DELOREAN MOTOR CARS OF AMERICA
Division of DeLorean Motor Company

SERVICE BULLETIN

NUMBER ST-07-9/82

CATEGORY: TECHNICAL
ATTENTION: ALL DMC DEALERS/SERVICE MANAGERS
SUBJECT: ADJUSTABLE CLUTCH LINK - MANUAL TRANSMISSION

Figure 1
OLD CONDITION

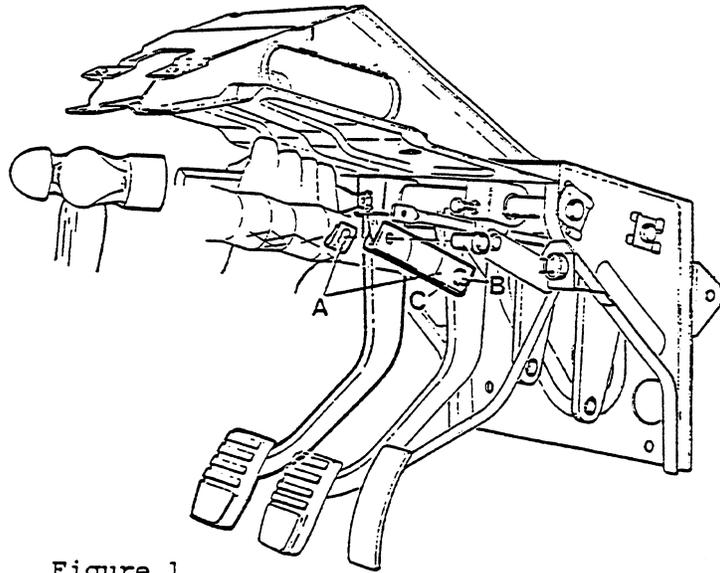
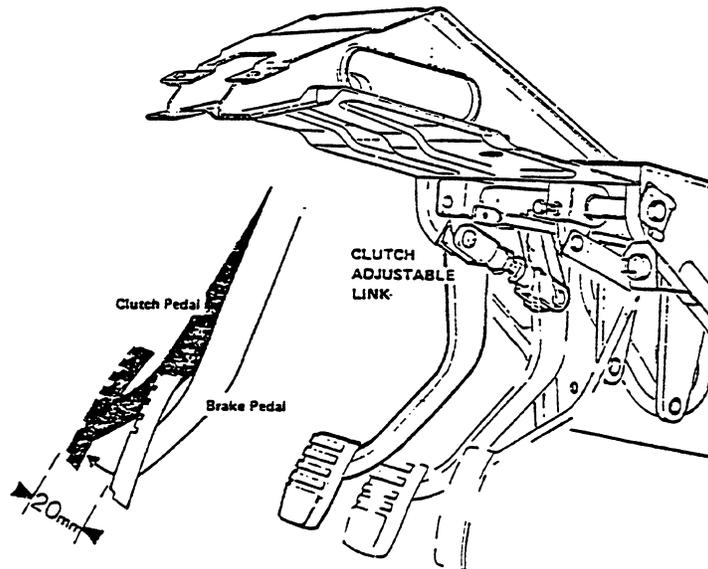
The clutch pedal stop bolt and weld nuts must be removed to permit the pedal to be raised. To carry out this operation, the following procedure should be observed (Figure 1).

- C) Unscrew the 10 mm clutch pedal stop bolt from the top of the pedal box and discard.
- D) Using a hammer and sharp chisel carefully shear off the 10 mm clutch stop nuts welded on both sides of the pedal box (Figure 1).
- E) Assemble the adjustable clutch link (Figure 2) (Part Number 133188). Adjust both clevis ends evenly on the threaded rod so as when the link is secured the clutch pedal is 20 mm (3/4") higher than the brake pedal (Figure 3).
- F) With the link adjusted and positioned install the clevis pins.
- G) Reinstall spring clips to retain clevis pins, and tighten lock nuts.
